NUCLEAR ENERGY INSTITUTE

Subject: Industry Comments on Draft NUREG 1924, "Electric Raceway Fire Barrier Systems in U.S. Nuclear Power Plants," Docket ID NRC-2009-0442

Project Number: 689

**Electric Raceway Fire
Barrier Systems in
U.S. Nuclear Power Plants**

Figure 4-1. Fire Barrier Testing Acceptance Criteria Flow Chart

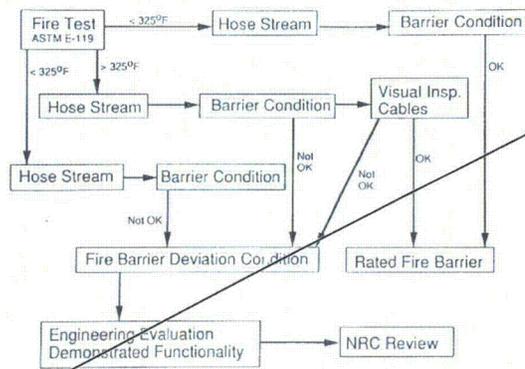
Author: Subject: Highlight Date: 11/30/2009 9:41:39 AM
 This figure is confusing or misleading. "NRC Review" is not neutrally performed, so what is the significance here?
 Box should be changed to "NRC Verification via Audit or Inspection"
